DEVELOPMENT REVIEW BOARD
SUPPLEMENTAL SUBMITTAL

PROJECT NO. PR-2021-006070

Re: Westpointe40 North Site Plan DRB Comment Responses (PR-2021-006070)

This memo outlines the responses and changes made to the site plan for the proposed 150K spec industrial building at Westpointe40 based on the comments received and reviewed at the December 15, 2021 DRB meeting.

TITAN 150K SPEC BUILDING ALBUQUERQUE, NM	DRAWN BY pm
	CONSTRUCTION DETAILS	DATE 12-22-21
	TIERRA WEST, LLC 5571 MIDWAY PARK PL. NE ALBUQUERQUE, NEW MEXICO 87109 (505) 858-3100 www.tierrawestllc.com	DRAWING 2020088-150K.DWG
RONALD R. BOHANNAN P.E. #7868		SHEET # SP-2
		JOB # 2020088

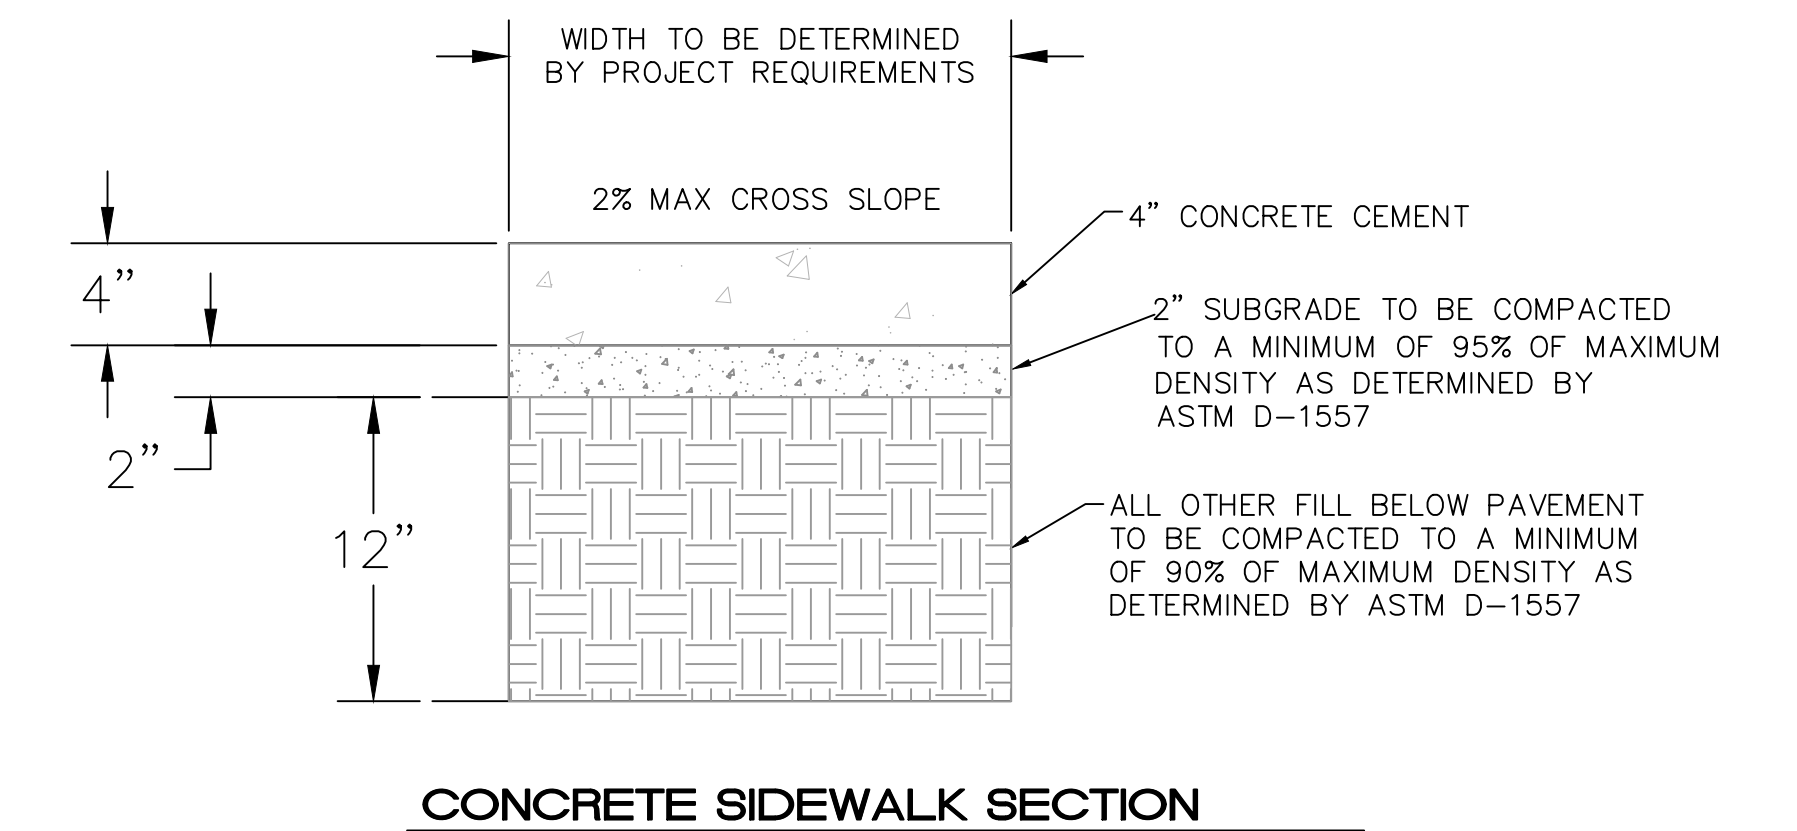
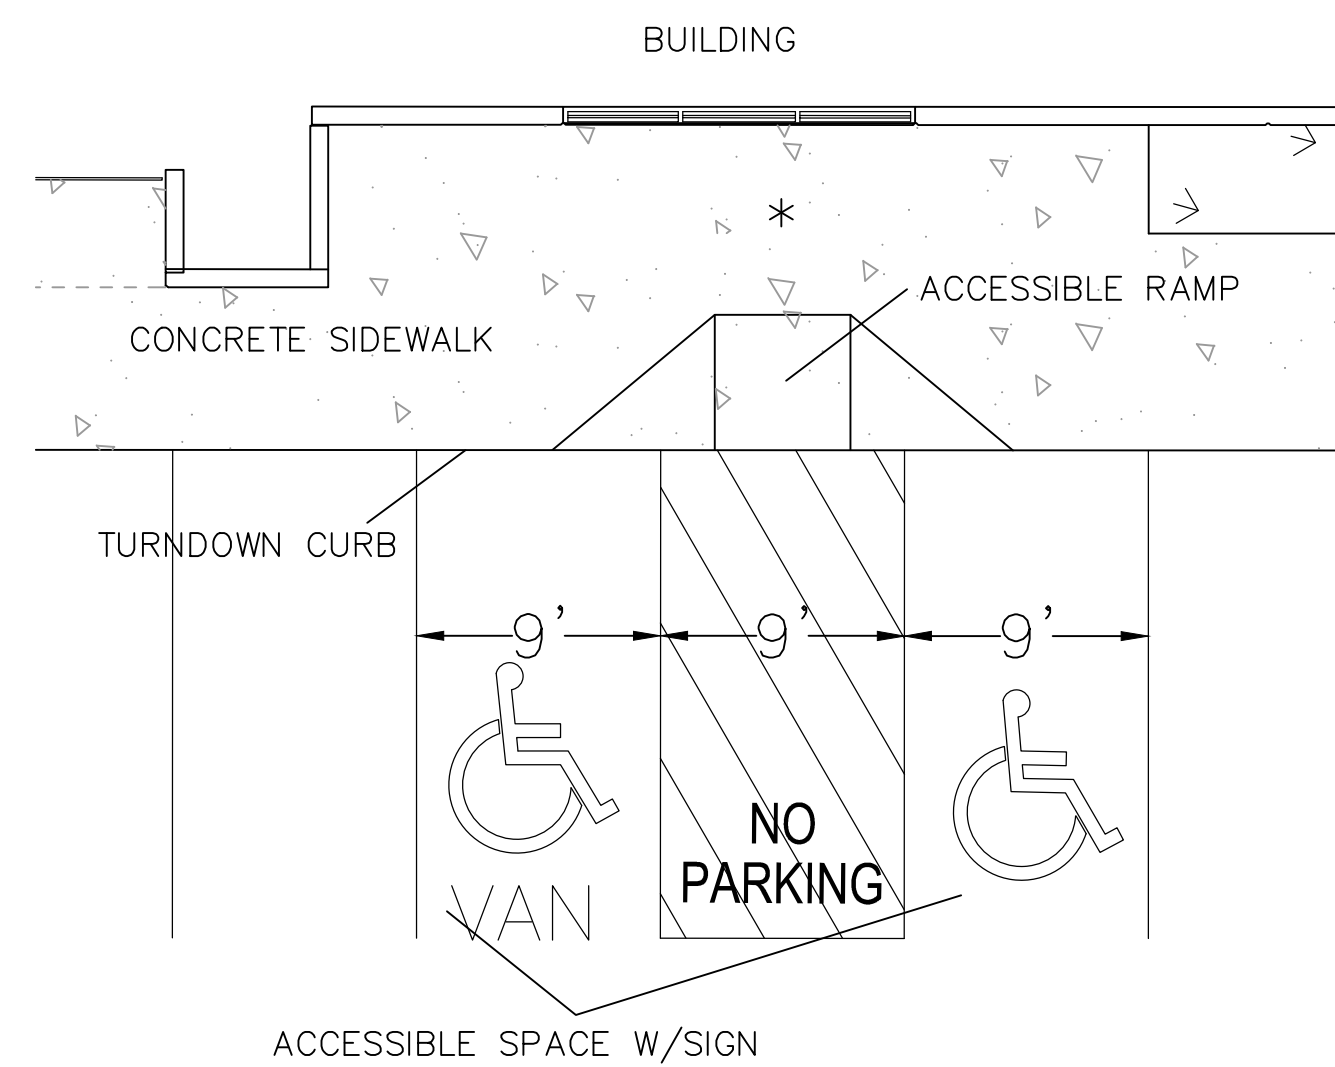
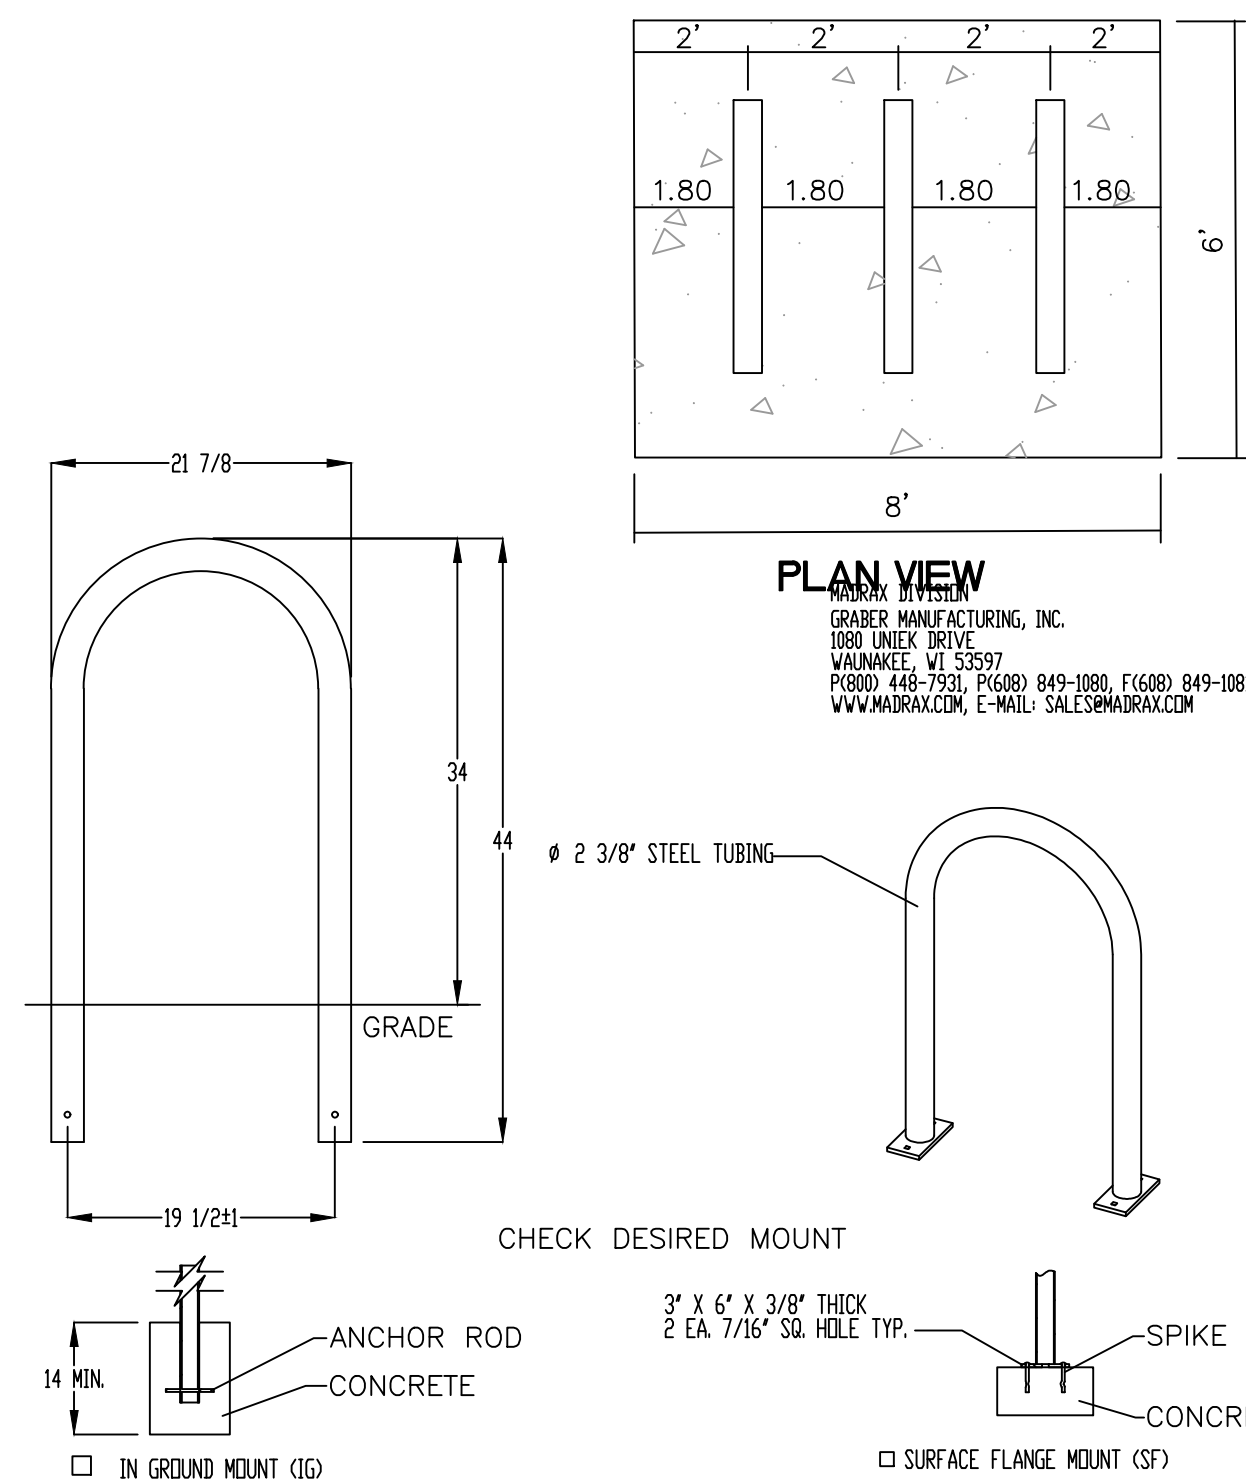
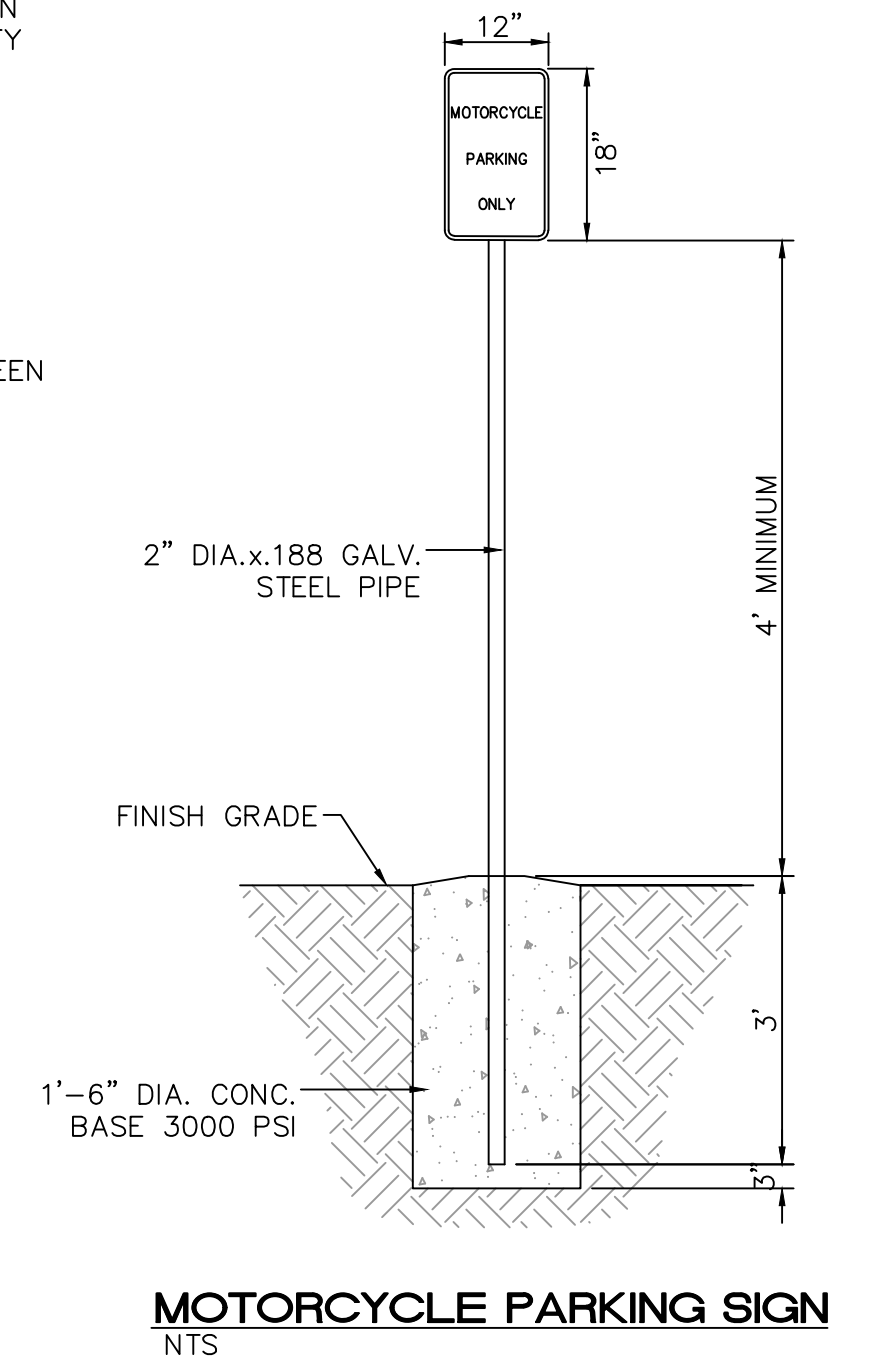
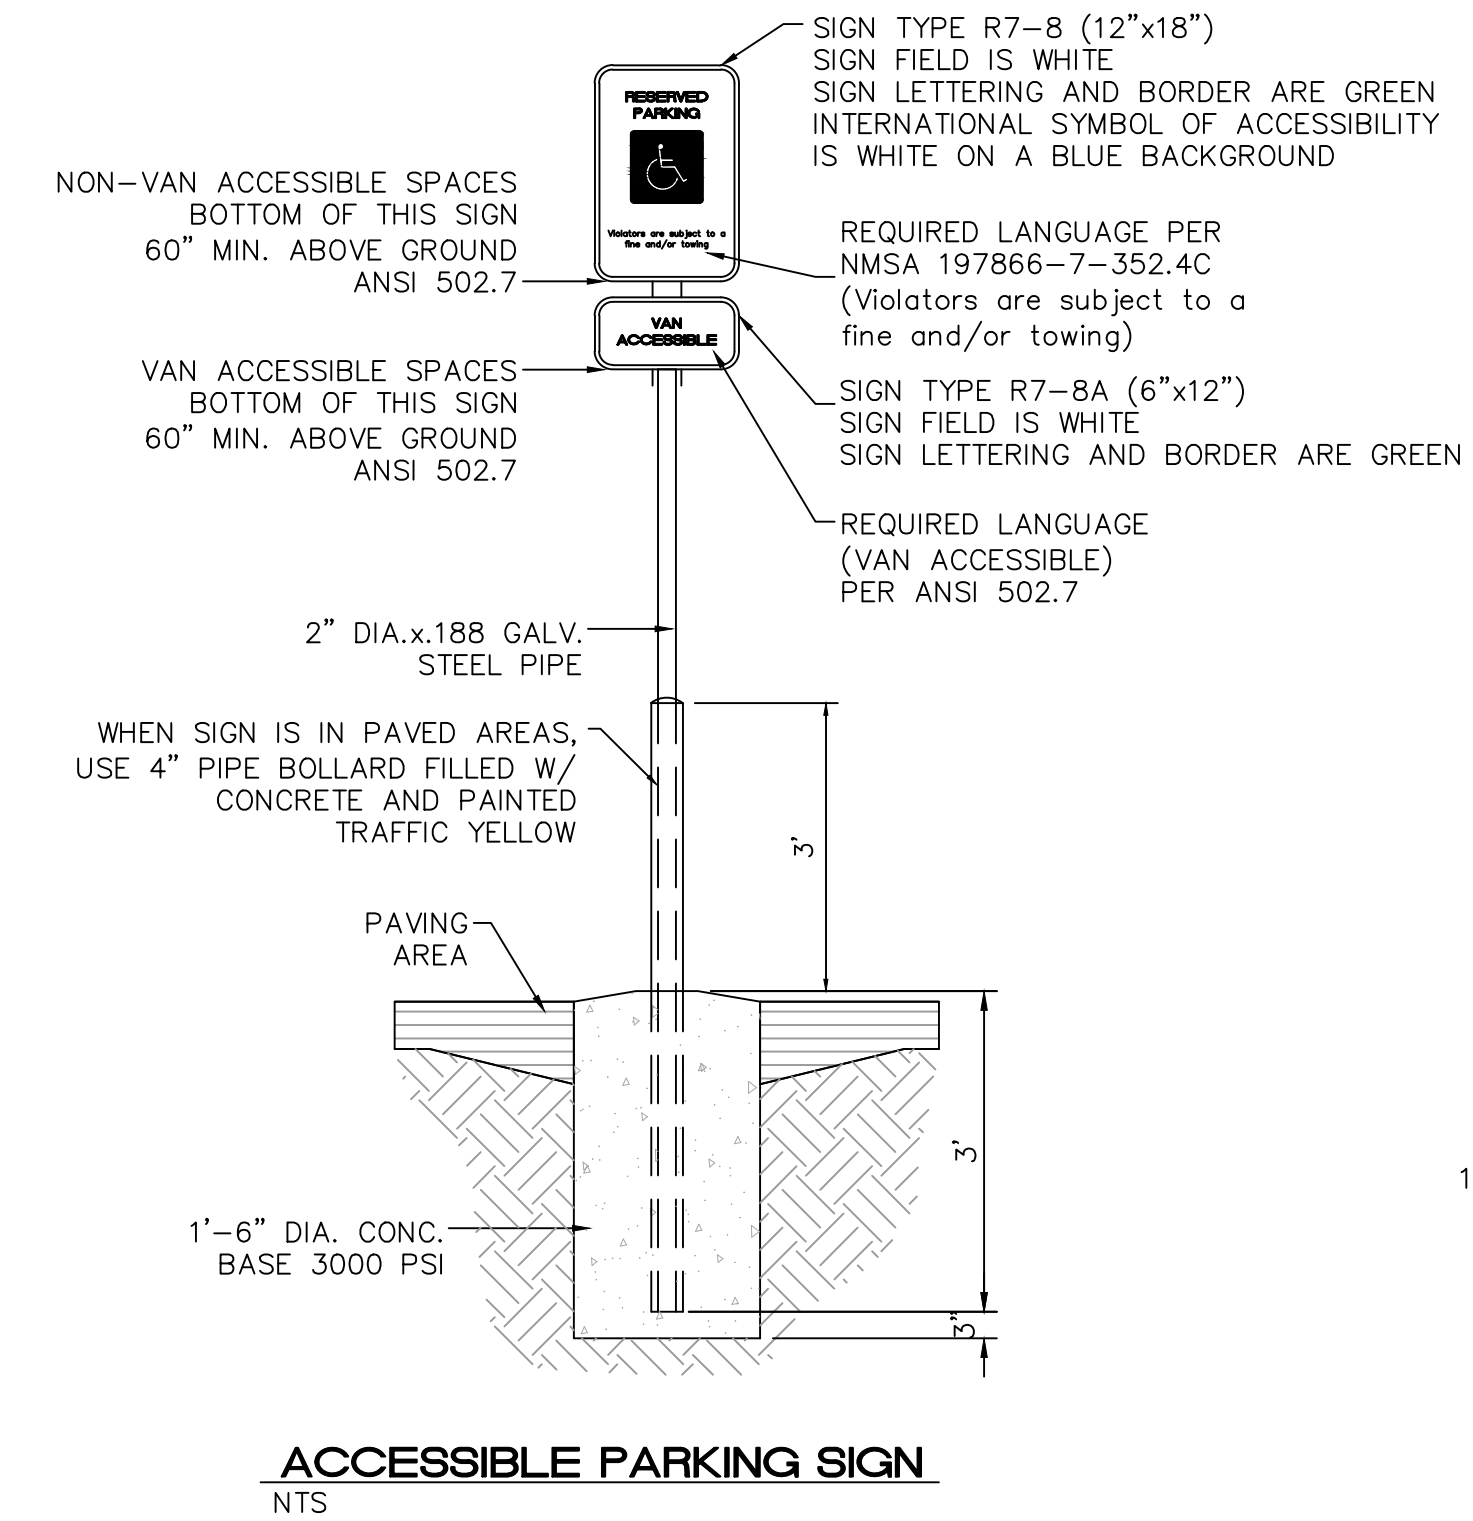
5. Include the sidewalk details on the Det-1 sheet provided. Specify the 2% maximum cross-slope on the sidewalk.
 - *The details sheet has been updated to specify the cross slope.*
6. On the curb ramp detail for van accessible aisle provided, include dimensioning, or specify minimum required dimensions for both the ramp and area between the ramp and building.
 - *A note has been added to the accessible parking/curb ramp detail specifying the minimum dimensions required between the ramp and building.*
